Project: two storey side extension to 1 Fern Street Waterfoot Rossendale

Application Number:	2019/0035	Application Type:	Full
Proposal:	Householder: Erection of two-storey side extension	Location:	1 Fern Street Waterfoot Rossendale Lancashire BB4 9BL
Report of:	Planning Unit Manager	Status:	For publication
Report to:	Development Control Committee	Report Written:	22 nd May 2019
Applicant:	Mr Grant Kempson 37 Parkwood Drive Waterfoot Rossendale BB4 6RP	Determination Expiry Date:	19 th June 2019
Agent:	N/A

1. RECOMMENDATION

That the Committee refuse planning permission for the reasons set out in Section 9.

Proposed front Elevation

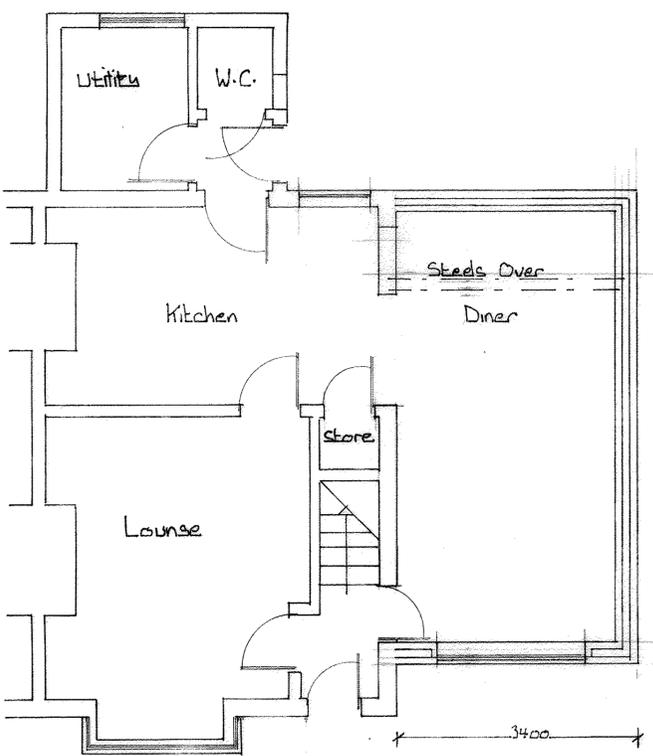
The development would extend 4m beyond the original side wall and in doing so would almost double the width of the property (the original dwelling is 5m in width). The extension has a length of 7m, which is 0.5m less than the length of the original dwelling. The property is located on a prominent corner plot and the proposed ground floor of the extension would be raised approximately 1m above the adjacent Pleasant View Road and properties on this road as shown in Photograph 1 below.

- The extension is set back 0.5m from the front elevation (the SPD does not state a minimum amount)
- No boundary treatment details have been provided
- There is a distance of 6.6m from the side of the original dwelling to the property boundary, and the extension is 4m in width. As such the extension occupies more than half of the available width of the side area. However, the extension will leave a gap of 2.6m to the boundary and highway.

In light of the above findings, officers conclude that the extension does comply with the requirements of Section 3.5 as the extension is set back from the front elevation and leaves a gap of 2.6m from the side to the highway. Whilst no details of boundary treatment have been provided, this could be secured by planning condition.

Notwithstanding the above, the ground level for the proposed extension is around 1.5m higher than the street level on Pleasant View. By reason of its scale and massing and height above ground level, Officers consider that it will have a detrimental impact on the

visual amenities of the street scene, particularly when viewed from Pleasant View which is a narrow residential street.

Proposed Rear Elevation

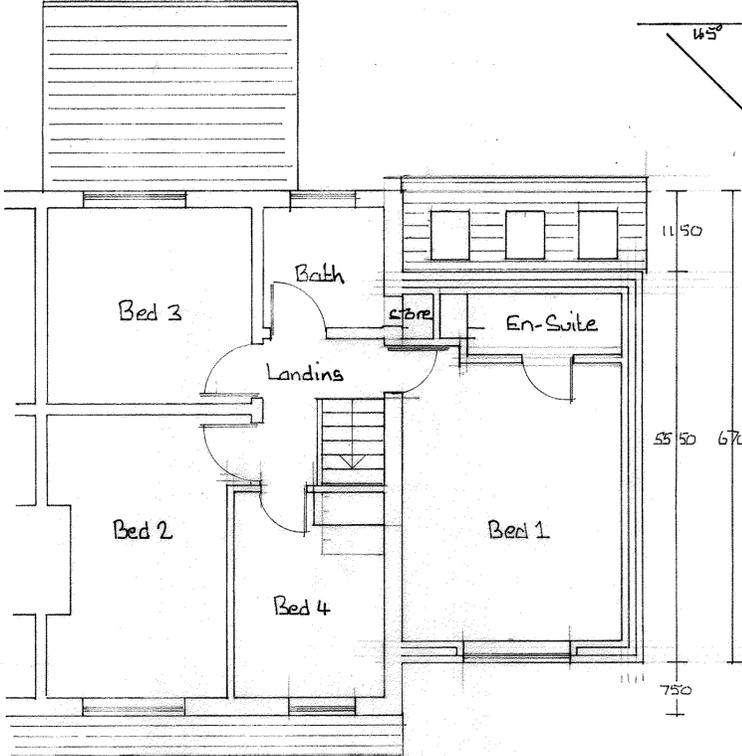
3 Park View is located to the rear of the application property, and 1 Park View is located at the end of the row and opposite the location of the proposed extension (as shown in photograph 3). 1 Park View currently enjoys an open aspect with windows looking on to the side garden of the application property. The proposed extension would be located directly opposite 1 Park View, at a distance of 16m away, and with a bedroom window located on the rear elevation at first floor level. The SPD states that there should be 20m minimum distance between first floor windows serving habitable rooms in order to provide reasonable levels of privacy.

With a shortfall of 4m Officers consider that the extension would enable overlooking to the existing windows at 1 Park View, resulting in an unacceptable loss of privacy for its occupiers. 1 Park View is a 'back to back' property meaning that all bedroom windows will be affected. Officers attach significant weight to the harm caused to the neighbours by way of loss of privacy.

Officers have considered whether the development could be made acceptable with the use of obscure glass to the rear facing bedroom window. The bedroom is proposed to have only one window, and if this were to be obscure glazed it would not allow a reasonable outlook from it, which would be detrimental to the amenity of its occupier.
